Access Compliance Report

Public Rights-of-Way

(Curb Ramps)

Intersection ID: 10041433	Main Street: WESTINGHOUSE_BV	Cross Street: N/A	Location: SE
ADA ID: 03F70B872C47	Ramp Type: PerpDiag	Initial Pass/Fail: Fail	Overall Compliance: No
Severity Score: 21.25			
Codes/Mitigation Info/Possible Solution		Field Measurements/Component Compliance

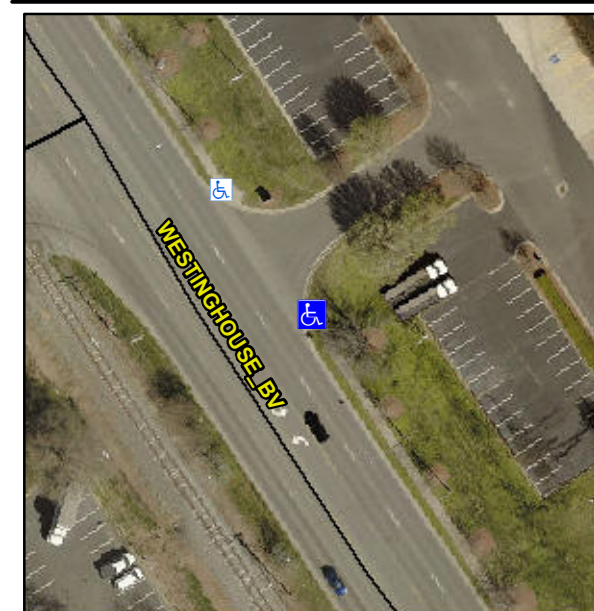
R304.5.1, R304.5.3

Compliance	Description	Data	Compliance	Description	Data
N/A	Ramp Length (in)	86.0	Yes	Ramp Slope (%)	5.2
No	Ramp Width (in)	38.0	No	Ramp XSlope (%)	6.2
N/A	Flare Type LT	N/A	N/A	Flare Type RT	N/A
N/A	Flare Slope LT (%)	N/A	N/A	Flare Slope RT (%)	N/A
N/A	Flare Traversable LT?	N/A	N/A	Flare Traversable RT?	N/A
N/A	Landing Length (in)	N/A	N/A	DWS Provided?	N/A
N/A	Landing Width (in)	N/A	N/A	DWS Contrast?	N/A
N/A	Landing Slope (%)	N/A	N/A	DWS Length (in)	N/A
N/A	Landing X Slope (%)	N/A	N/A	DWS Full Width?	N/A
N/A	Landing Curb? (Y/N)	N/A	N/A	DWS Offset (in)	N/A
N/A	Shared Landing?	N/A			
N/A	Gutter Ponding?	N/A	N/A	Gutter Slope (%)	N/A
N/A	Gutter Lip Ht (in)	N/A	N/A	Gutter X Slope (%)	N/A
N/A	Painted X Walk1?	No	N/A	Painted X Walk2?	No
	X Walk 1 Direction	To N		X Walk 2 Direction	To W
N/A	X Walk 1 Width (in)	N/A	N/A	X Walk 2 Width (in)	N/A
	X Walk 1 Slope (%)	1.6		X Walk 2 Slope (%)	1.5
	X Walk 1 X Slope (%)	3.7		X Walk 2 X Slope (%)	0.3

Remove & Replace Curb Ramp With Two New Directional Ramps or Equivalent.
